SPECIAL SERVICE NOTE⊨

Early production (Series 1) of Sawzall 6536-21 with serial break 'A' will have a 'Red' spindle seal (45-06-0115) and two steel washers (45-88-8577).

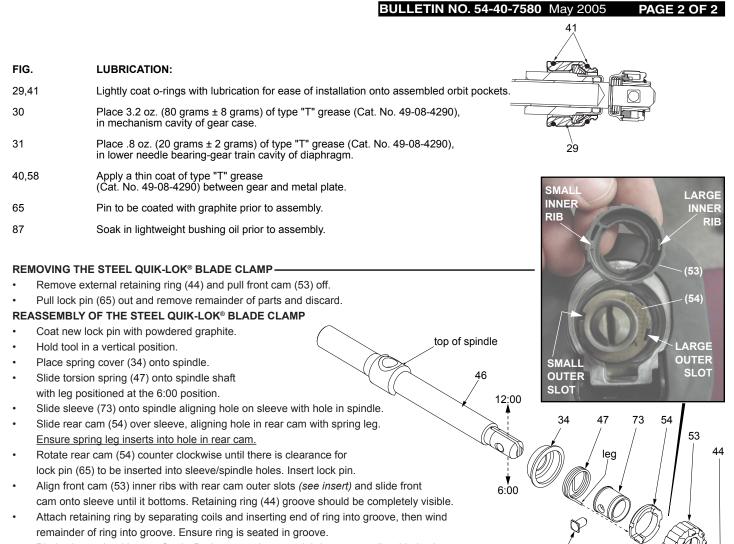
'Red' spindle seal No. 45-06-0115 is obsolete with no direct replacement.

When servicing Series 1 (A) revision Sawzalls (SN A66A605182665 or less) with worn out / damaged 'Red' spindle seal, the following needs to be done:

- use the existing front orbit cap No. 44-86-0035.
- use one of the existing steel washers (discard the second washer).
- · discard worn out / damaged 'Red' spindle seal.

- place one steel washer (45-88-8577) inside front orbit cap.
- place felt seal (45-06-0501) inside front orbit cap. (Soak in lightweight bushing oil prior to assembly).
- place / press polypak seal (45-06-0475) inside front orbit cap. (O-ring of polypak seal must face mechanism - toward rear of tool).
